PERCOLATION TESTING

HOWARD COUNTY HEALTH DEPARTMENT  
BUREAU OF ENVIRONMENTAL HEALTH  
PO BOX 476 ELLICOTT CITY, MARYLAND 21043  
TELEPHONE: 461-9933

RE: 13823 Old Frederick Road

This office has received your building permit # 36670.  
We are unable to approve your permit for the following reason(s):

A 42888

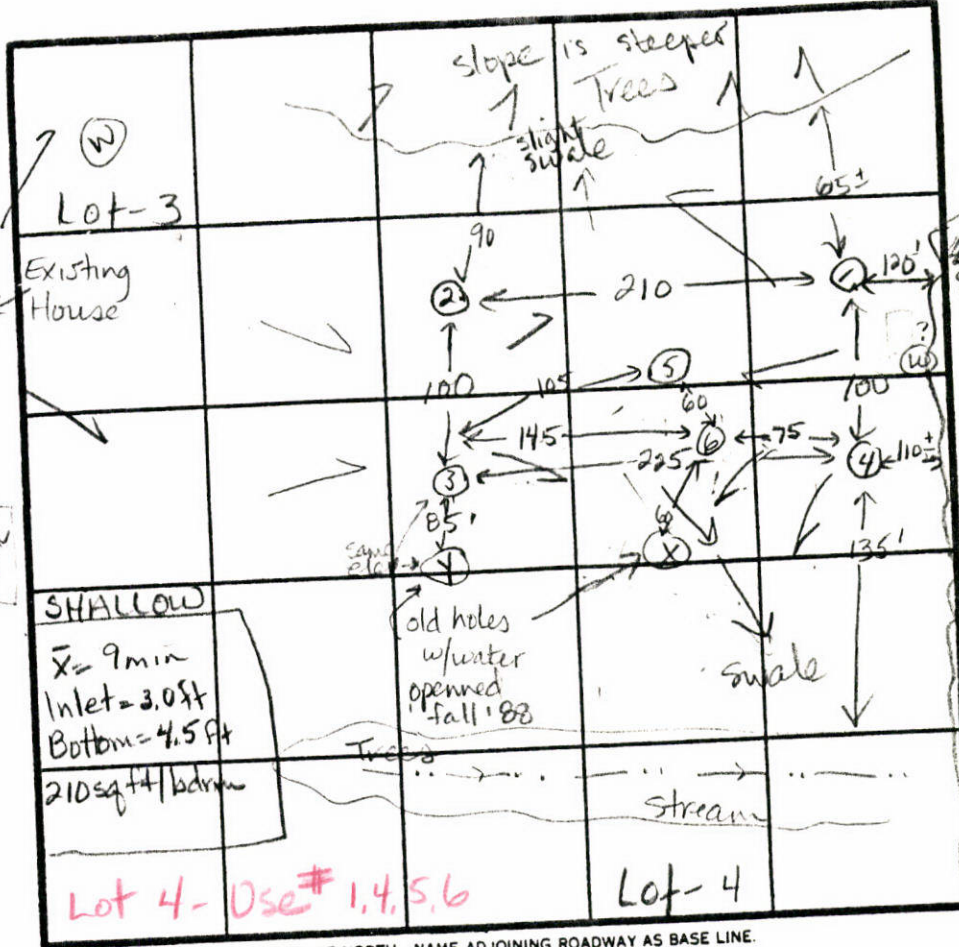
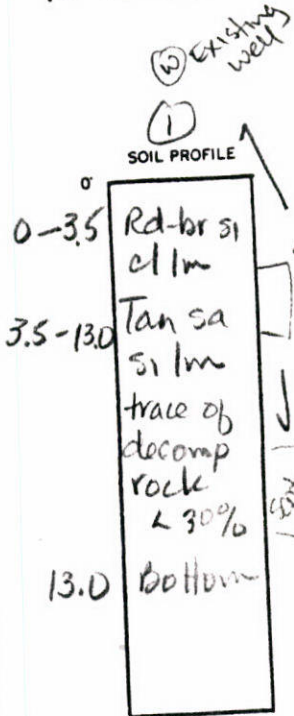
REASONS FOR REJECTION OR HOLDING 3-22-89 For perc hole locations and plat approval. JEN.

REMARKS All holes different than originally plotted. Possibility of 2 lots of house and well sites are available. SHALLOW ONLY

Lot 4 Oakland Farms  
 Hilltop Development Corporation  
 P.O. Box 208, Clarksville, MD 21029  
 (301) 531-5539

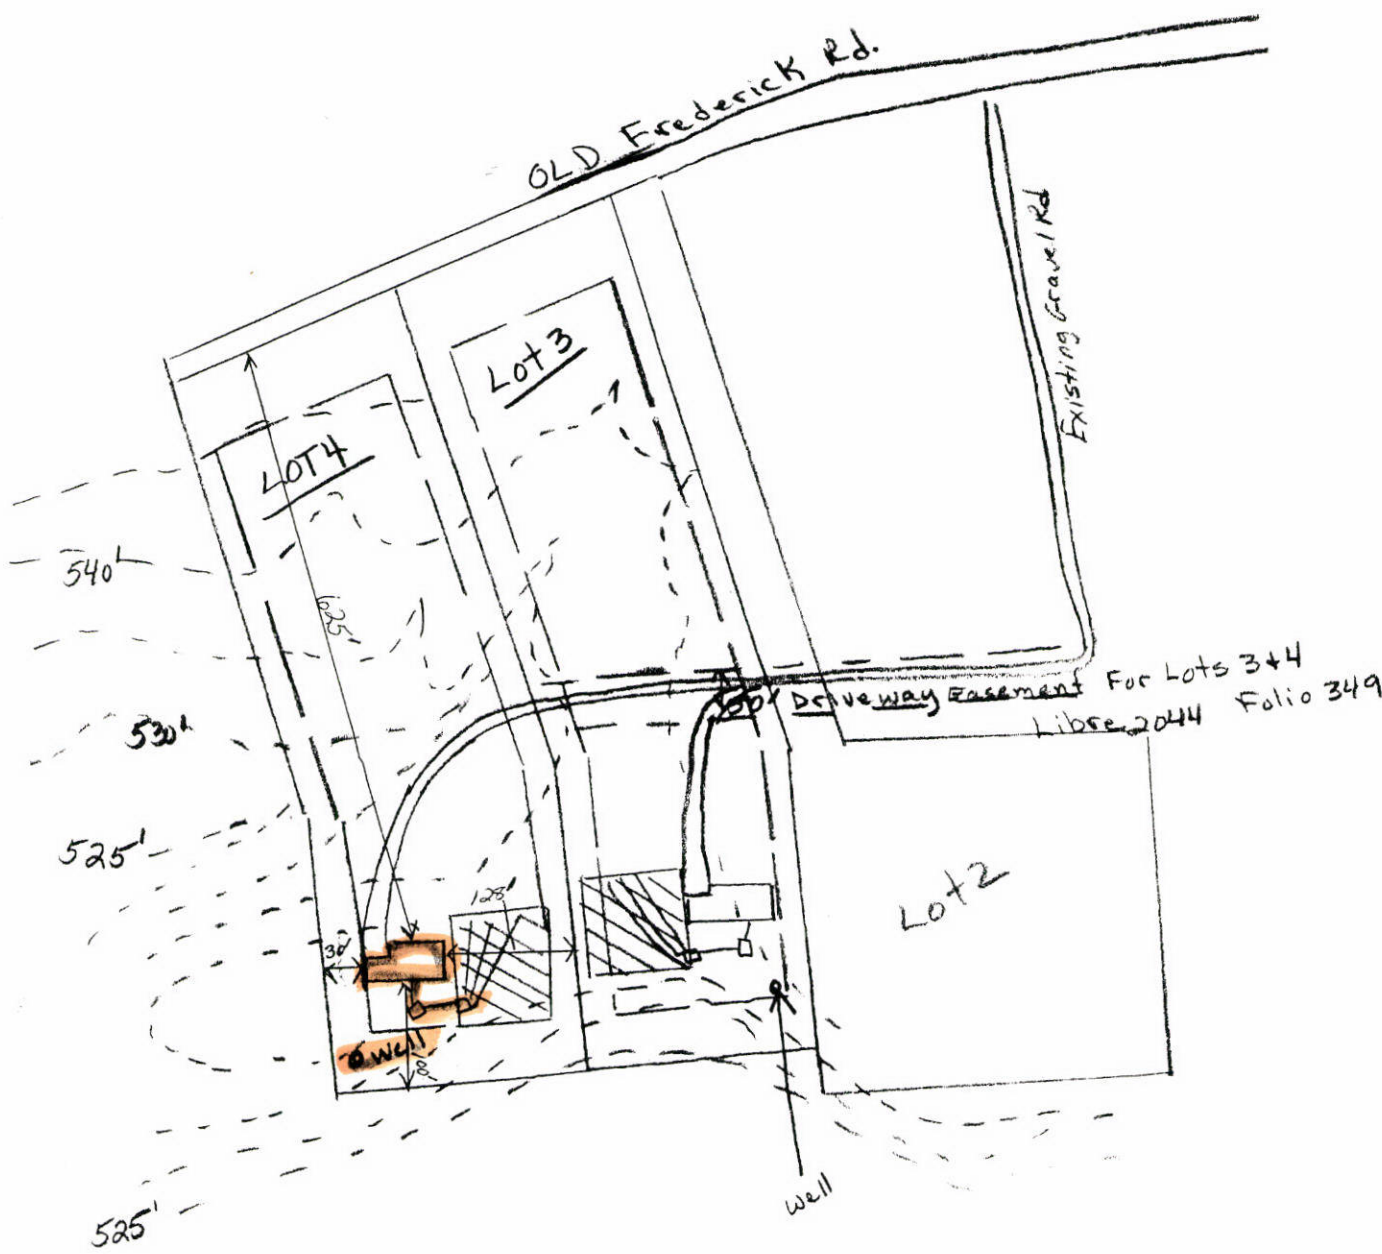
No septic elevations/site plans provided (example and septic specification enclosed).

No elevation at well.

A 42887

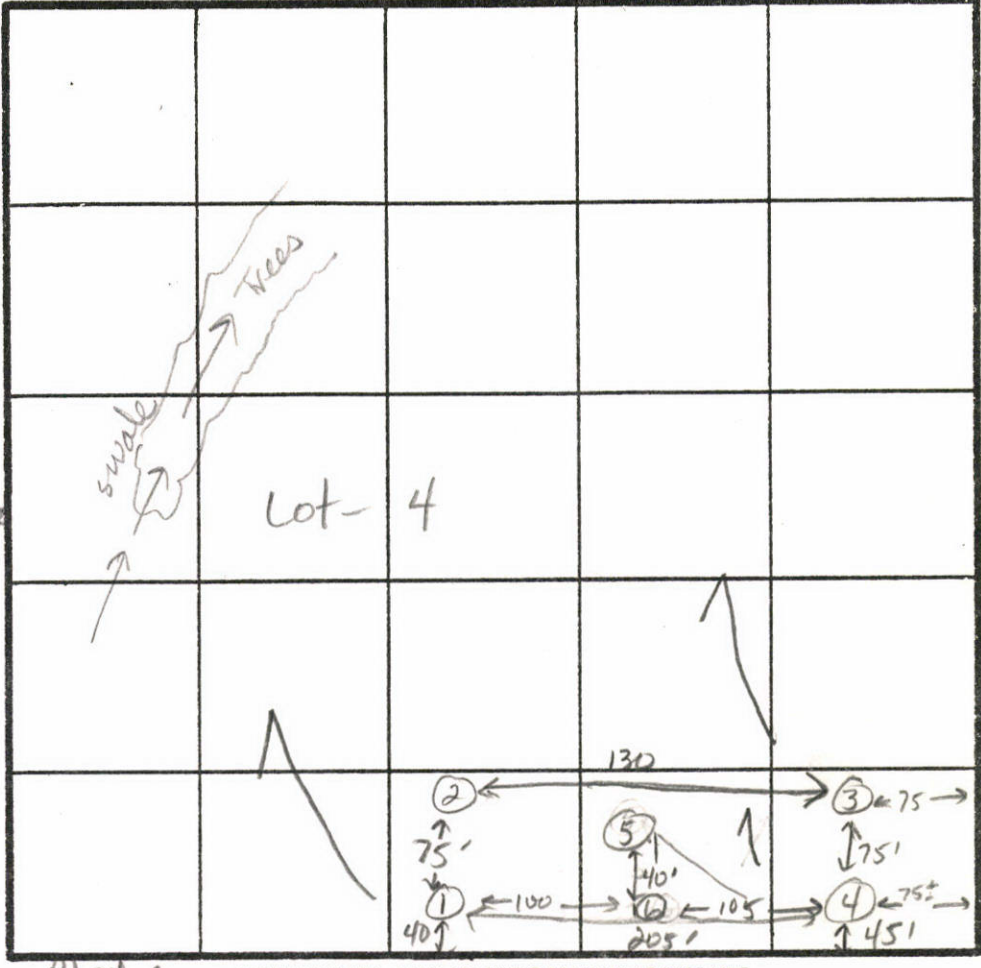
REASONS FOR REJECTION OR HOLDING 3-22-89 Recommend rejection. All holes had high water tables, no higher elevation for house or well. JEN

REMARKS No higher area for house or well site. 75 ft BRL along Old Fred. Rd. All holes moved from plat submitted w/ application.
